94-21-01 - LED Center Tail Light Assembly Deflecting Away from Body

Release date: 9/22/2021

Figure 1

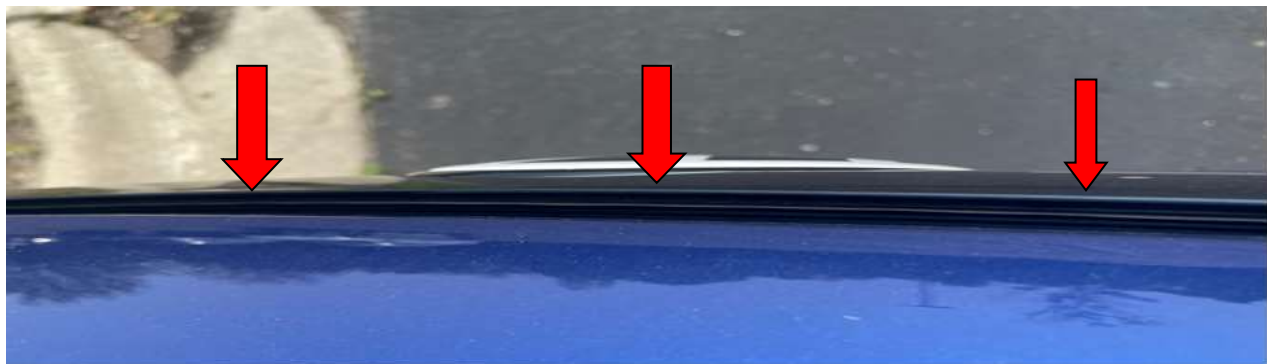
The LED tail light cluster is bolted to the rear lid on the left and right. The LED tail light cluster arches in the center outwards with a significant temperature change. As a result the LED tail light cluster is pushed out of its middle attachment clip and a gap between the rear lid and continuous LED tail light cluster is created. Figure 1.

Updated rear lid mounting grommet.

Figure 2

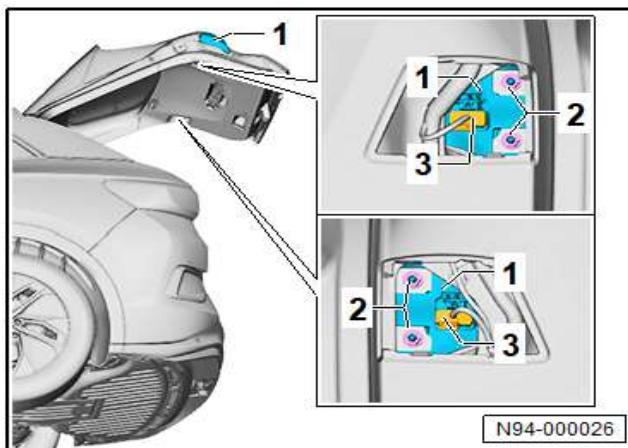
Apply Lithium grease (G 052 150 A2) or equivalent to the mounting points and install updated securing mountings (11A 945 179 A) or later suffix.

Figure 5

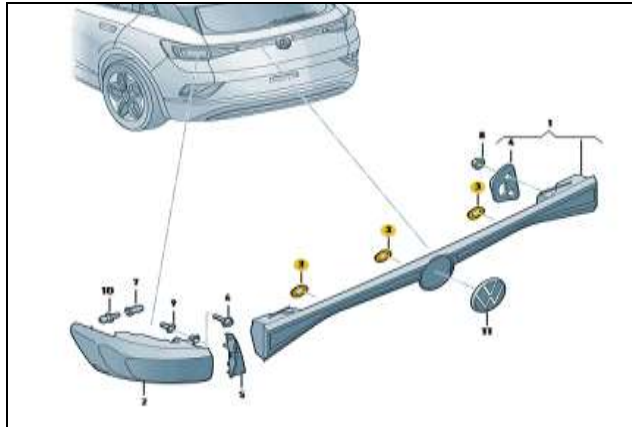
- Replace the 3 tail light mountings in the rear lid (see Figure 5, number 3 (in yellow) with part number 11A 945 179 A or later suffix.
- Reinstall LED tail light cluster in rear lid. See repair manual group 94 in Elsa.
